September 9, 2021

Product Substitution Notice - In-Wall® Slide-Out Aluminum Torque Shafts

Original torque shaft and components

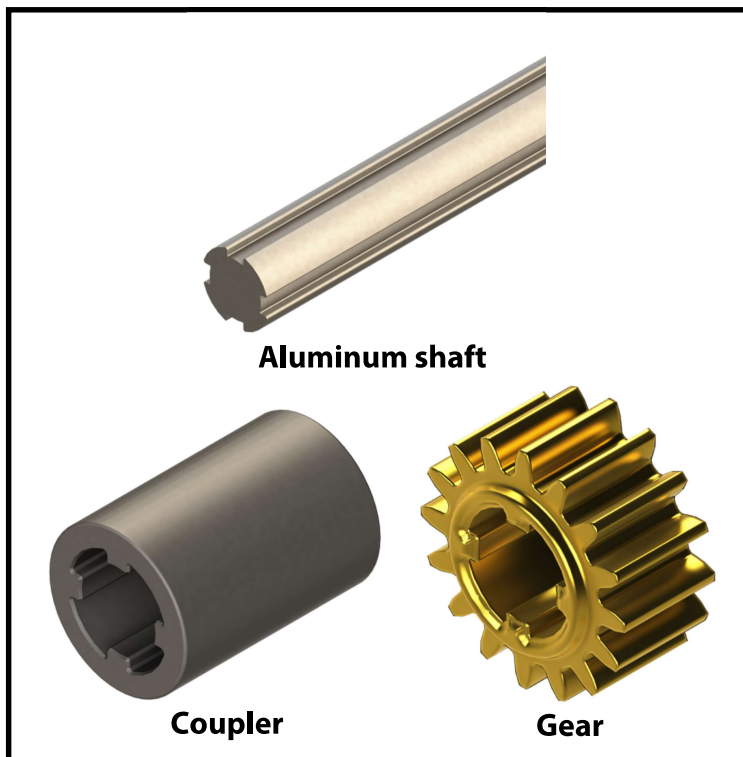
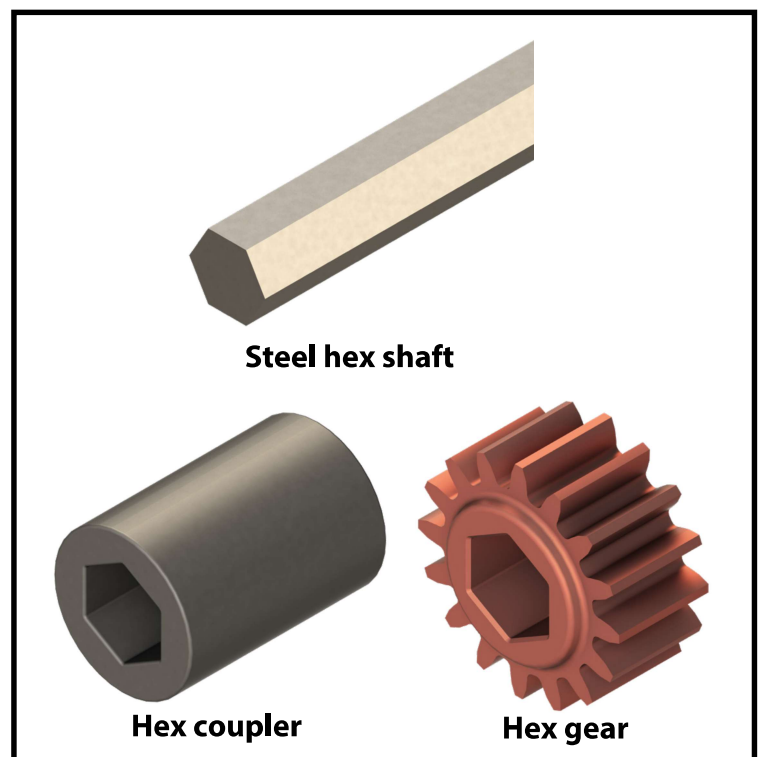
Due to materials shortages Lippert intends to substitute the aluminum torque shafts used in the lighter-duty applications of the In-Wall Slide-Outs with the steel torque shafts used in the heavy-duty applications.

There will be a slight weight difference in slides where this substitution is performed. The tallest slides will net no more than 5lbs total per system (2.5lbs per column).

Along with this change to the steel shaft, the coupler and gear used will also be changed to the heavy-duty versions.

NOTE: When ordering individual field service parts, shaft type must be identified using the illustrations above.
